RE: *ADDITIONAL INFORMATION RESPONSE*

Permission for the provision of 1 no. new dwelling house, entrance and all associated site works to the rear of the existing dwelling house at no. 6 Boden Villas, Taylors Lane. Proposed new dwelling to be accessed via new entrance from Palmer Park.

6 BODEN VILLAS, TAYLORS LANE, RATHFARNHAM, DUBLIN 16, D16 K7X2

Additional Information Response Planning Report

Private Open space and front Garden area 6 Boden Villas.

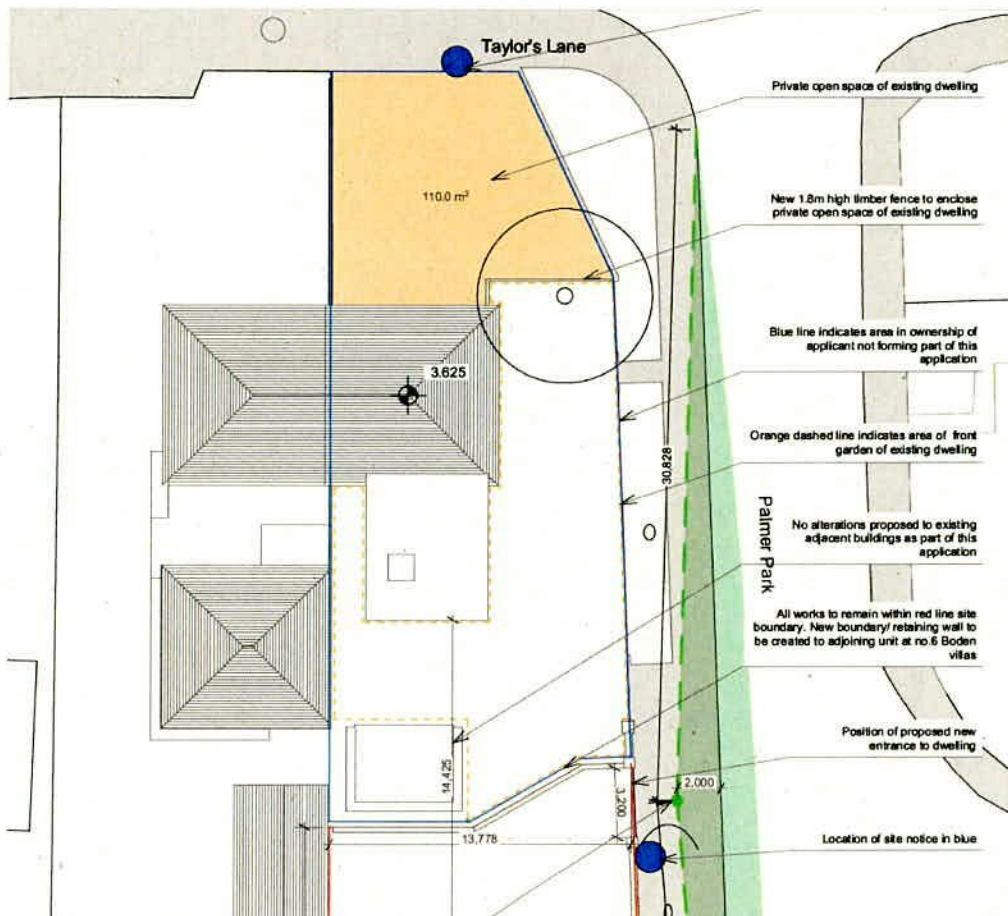
Additional information request 1:

The planning authority has concerns regarding the quality of private amenity space for the existing dwelling at 6 Boden Villas. The applicant is requested to consider more appropriately designed and located private open space for the existing dwelling. The South Dublin County Development plan 2016-2022 states that private open space should be located behind the front of the building line of the house and be designed to provide adequate private amenity. The area of private amenity space identified for the existing dwelling is located to its side, given that this dwelling is accessed and faces Palmer Park. However since this site is a corner site, the private amenity space is located forward of the building line of the existing house when facing Taylor's Lane. The area to the south of the existing dwelling is surfaced and appears to be used for car parking. Changes to the walls along the north and eastern boundaries to make them higher will not be acceptable.

This work completed by the Local Authority has effectively made the east elevation the front of the house. The area of hard standing to the south of 6 Boden Villas is used for parking and is open to Palmer Park and is considered to be the front public garden to the house. The area to the north with a high garden wall to the corner of Taylor's Lane and Palmer Park is considered to be the private amenity space for the existing house. See excerpt from P02 (rev 3) below.

In our opinion this space provides adequate quality private open space for the existing dwelling. The area shown on the plan above is 110m² with established trees and has adequate provision for private amenity space for no.6 in compliance with SDCC development plan requirements. This plan also identifies the area of hard standing to the front of the house.

In order to further improve the quality of this private space it is proposed to erect a timber garden fence from the north east corner of 6 Boden Villas to the high section of wall on Palmer Park. This will provide additional screening to this private open space from Palmer Park and it will clearly designate this space as private open space.

Revised design to site entrance, maintaining existing street tree.

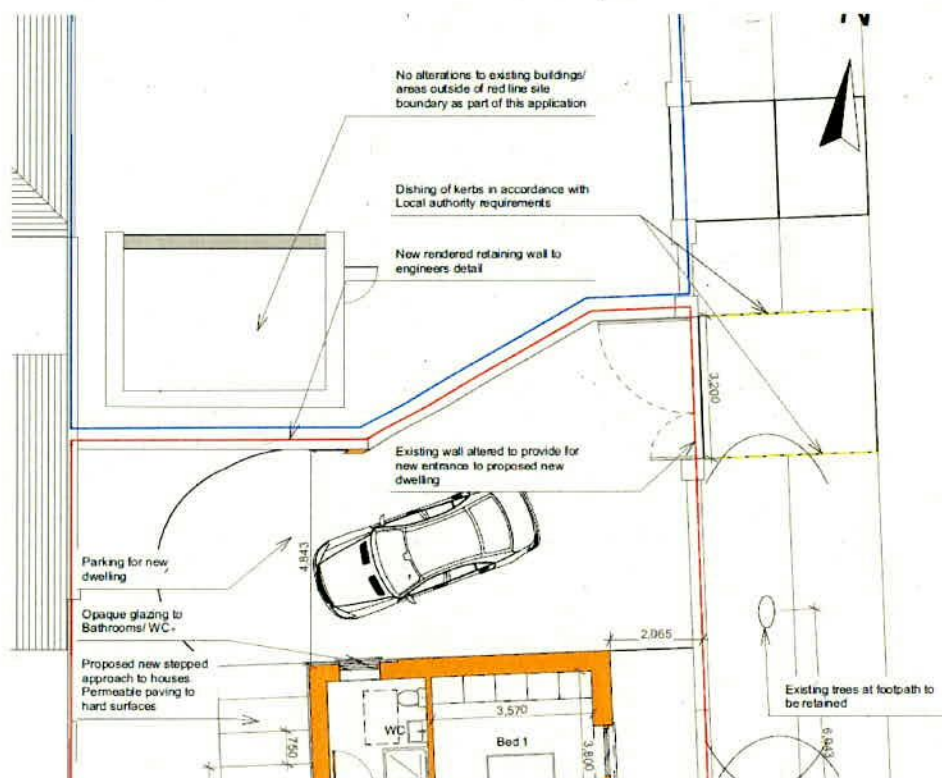
Additional information request 2:

The Public Realm section of the Planning Authority have concerns in relation to the removal of a street tree to provide for the new vehicular entrance. Insufficient information has been provided to justify the removal of this tree. The inappropriate removal of a street tree for a new vehicular entrance could set an undesirable precedent for similar developments. If the removal of this tree cannot be justified the layout of the development should be revised so that this tree is retained. This would involve moving the proposed vehicular entrance northward or providing a shared entrance with No. 6. The site boundary (red line) would need to be extended to include the relocated vehicular entrance and existing property at no. 6 Boden Villas. If the removal of this tree can be sufficiently justified in relation to Council Policy, this justification needs to be clearly set out. A letter of consent would be required from SDCC regarding these works. An appropriate replacement tree planted in the public realm would also be sought. This tree should be

appropriately located within the public realm and in relation to the existing utilities.

As part of the planning application, we included an assessment of the existing trees on the site and the damage they are causing to the roads, pavements and boundary walls. However we accept that it is preferable to retain this tree on site.

Therefore we are proposing the following changes to the design. The vehicular access to the site will be moved northward in order to avoid the tree and allow it to be retained on site. This work will include making a separate entrance to the new house, which is adjacent to the existing entrance to 6 Boden Villas. See excerpt from P03 (rev 3) below.

Please find enclosed revised drawings which show the position of this new entrance, the adjustment of the red line as suggested in the additional information request, and the retention of the existing street tree.
